# Addendum No. 06

April 11, 2024

## BAKERSFIELD COLLEGE STUDENT HOUSING (for DSA Project Name - New Residence Hall)

**PBK PROJECT NO.:** S2103400AR  
**DSA FILE NO.:** 15-C1  
**DSA APPLICATION NO.:** 02-122124

A6.6

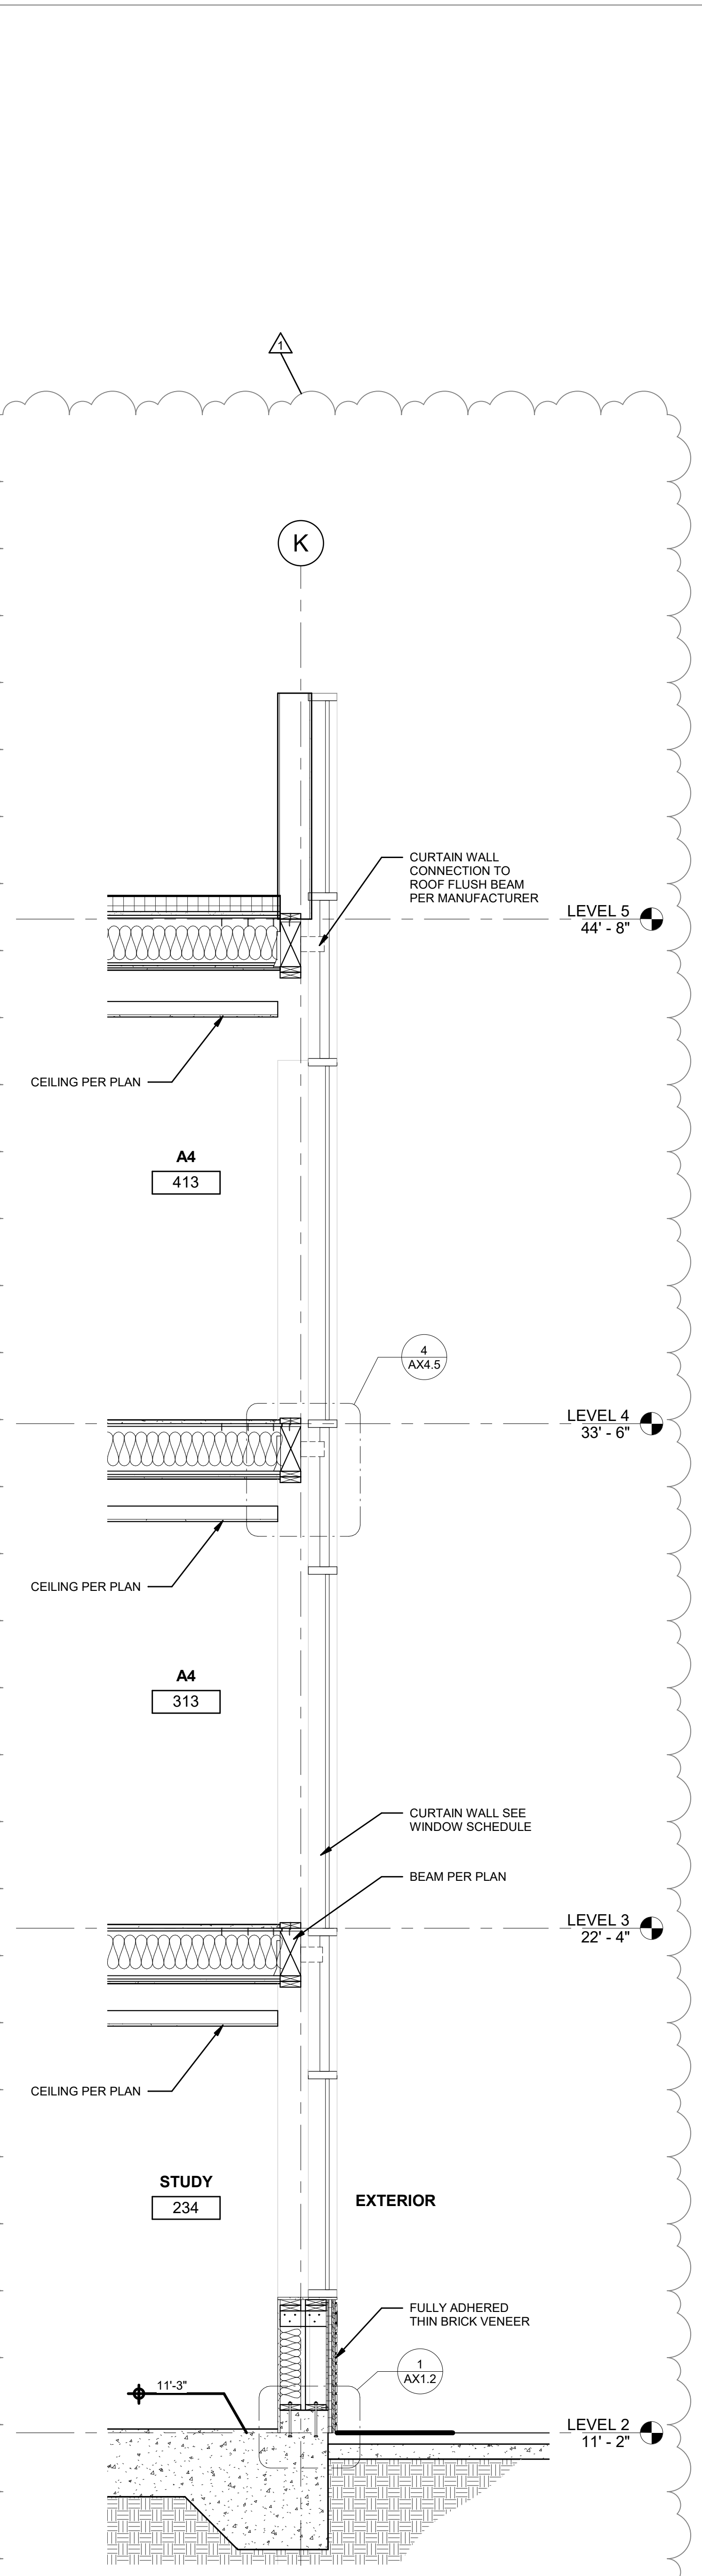
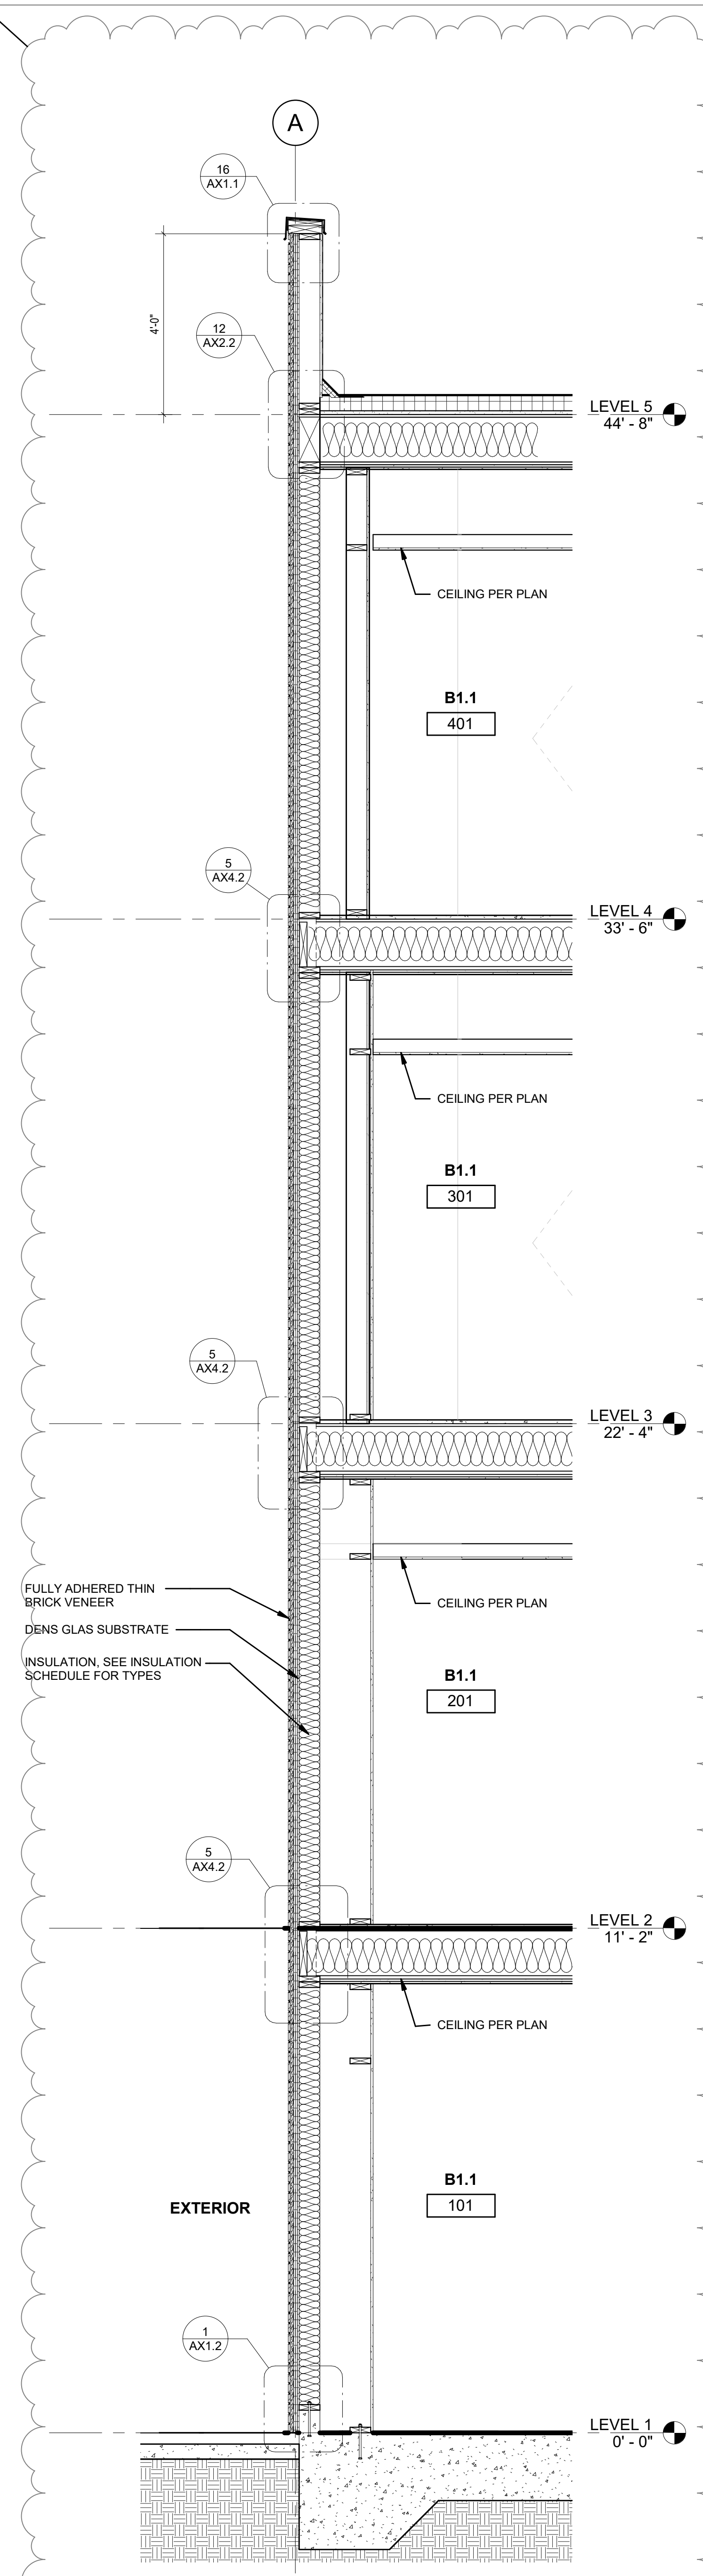
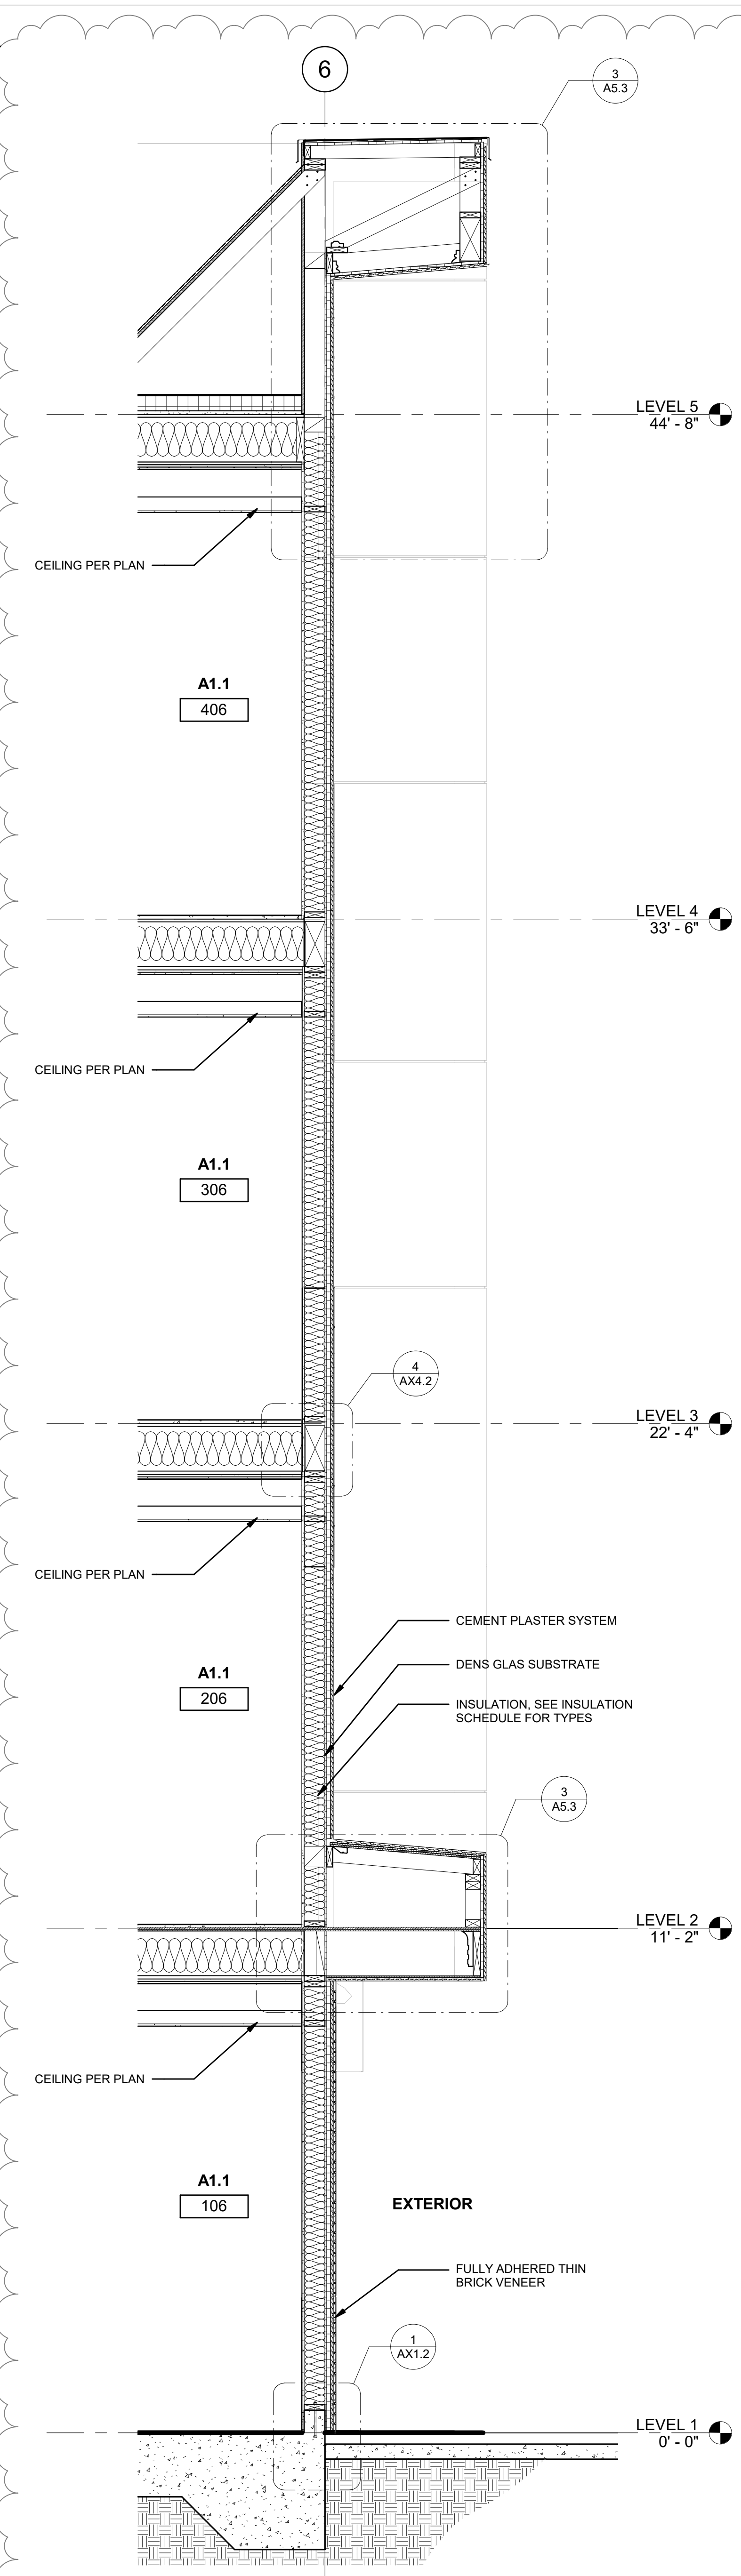
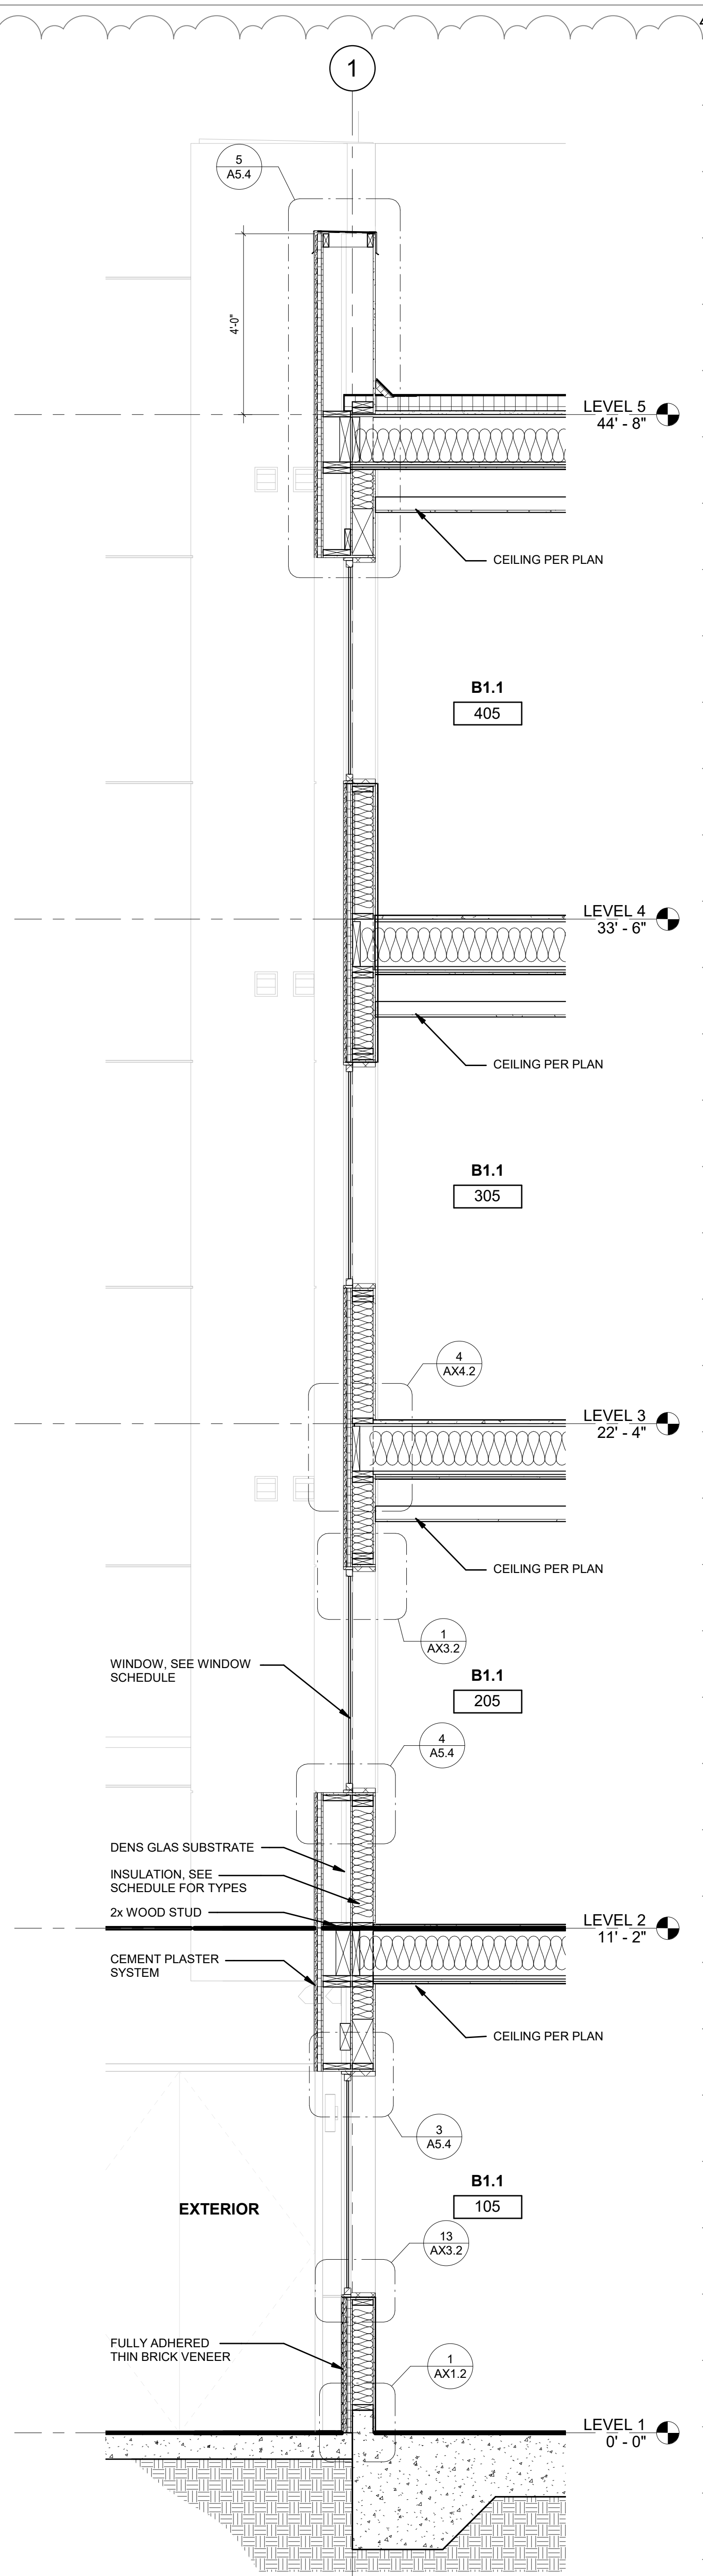
- AD6-24**    **A6.6 – Wall Sections:** Replace the sheet in its entirety. Revised references on drawings 1, 2, 3 and 4. See attached revised drawing A6.6 with all changes clouded.

BID  
**WALL SECTIONS**  
**A6.8**

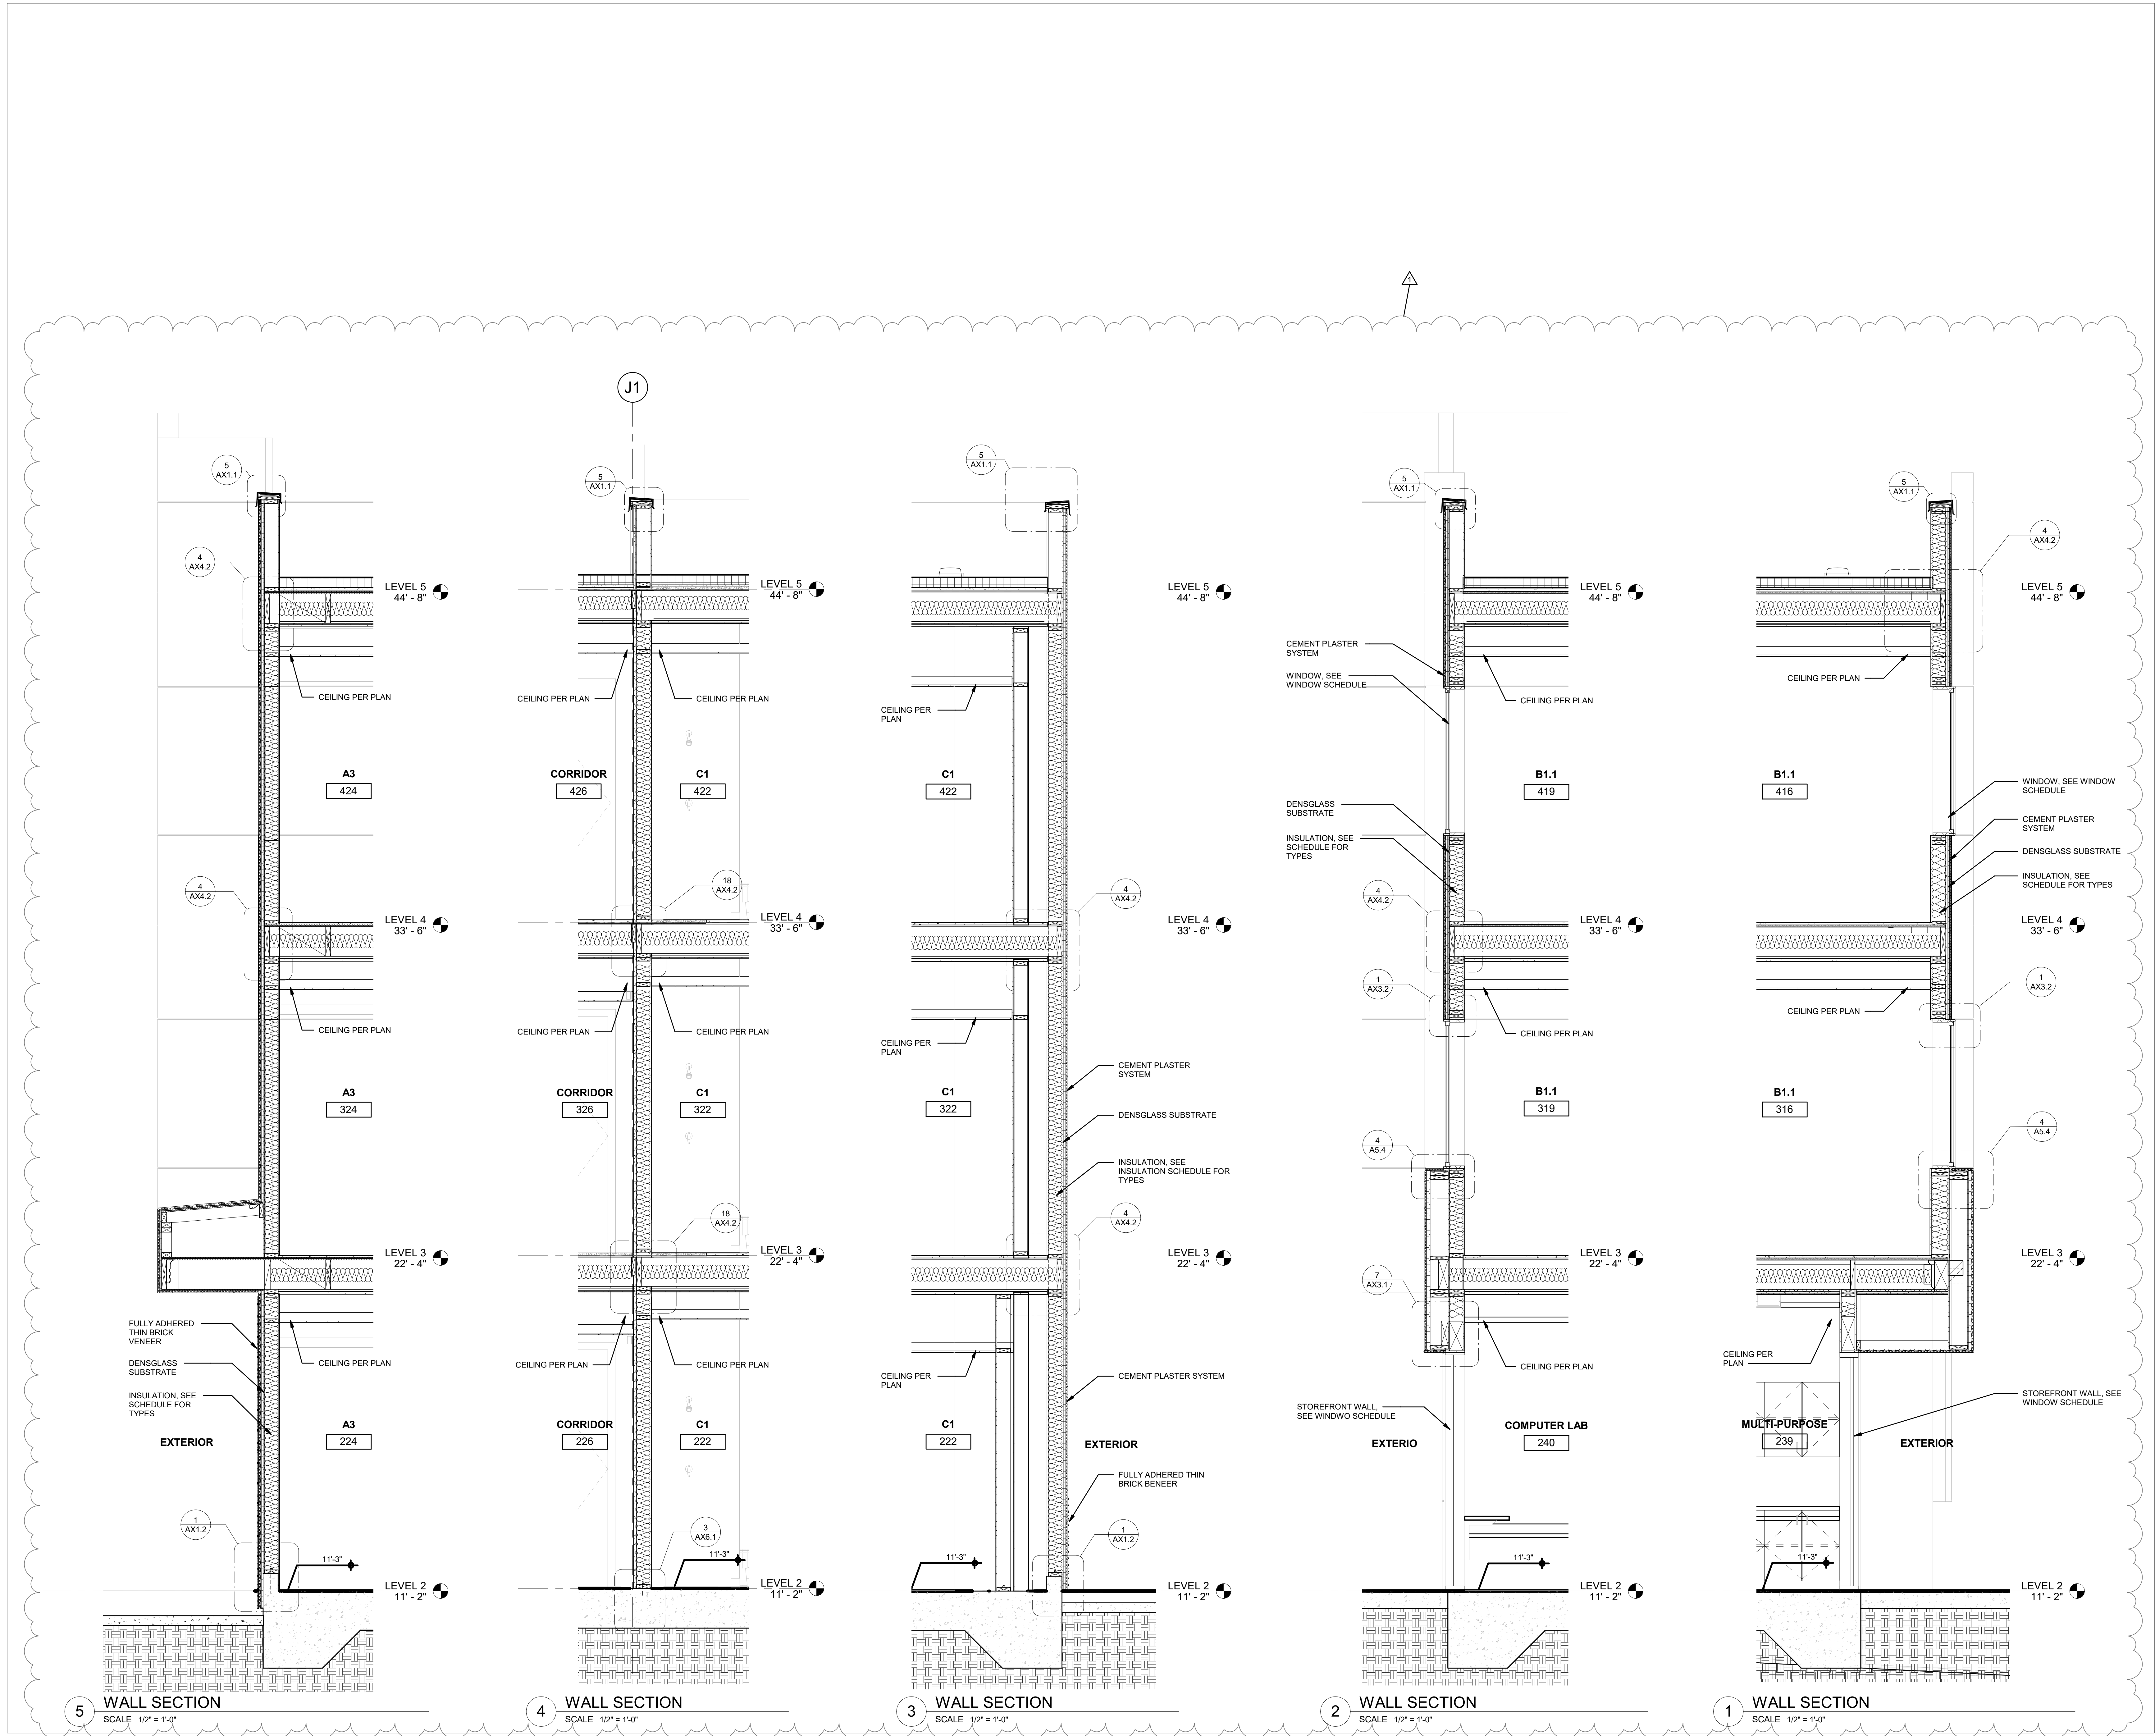
- AD6-26**    **A6.8 – Wall Sections:** Replace the sheet in its entirety. Revised references on drawings 1, through 5. See attached revised drawing A6.8 with all changes clouded.
